TECHNICAL BULLETIN

Product: HDK-79EC / HDK-79E / HDK-725P / HDK-720P

Symptom: Ret Switch pushbutton function on the handle cover is stuck on

HDK handle cover Ret Switch push button

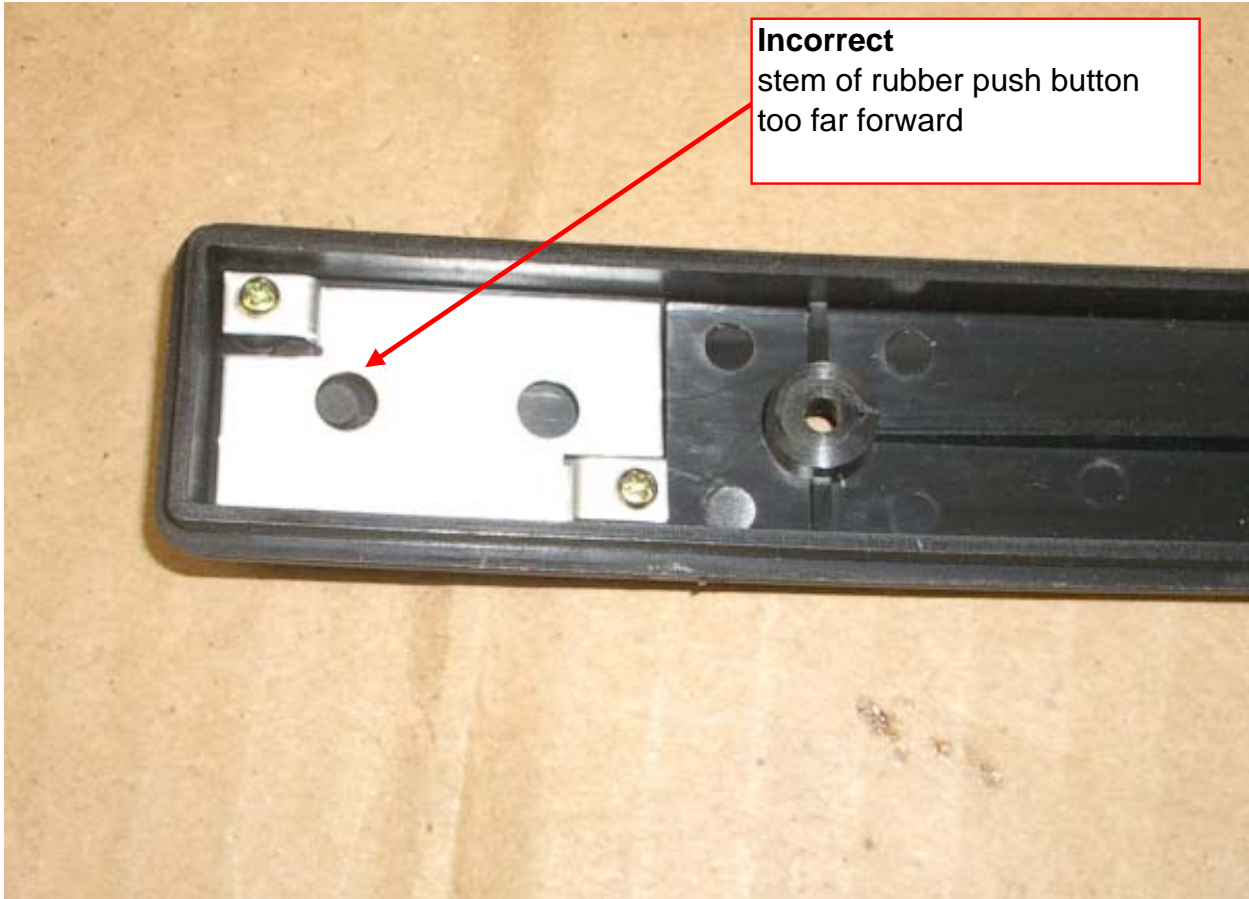
This problem can occur when the handle cover and/or the Ret Button is replaced. The Ret Switch Bracket holds the Ret Button in place. This bracket must be positioned and fastened in the correct orientation, or the stem of the push button will be too far forward and bind against the bracket, causing the Ret function to be activated continuously.

Incorrect
stem of rubber push button
too far forward

Refer to the photographs on the next page for the correct positioning of the bracket. If incorrect, remove the two screws, rotate the bracket 180°, and reattach with the screws.

Correct
stem of rubber push button
falls in center of hole
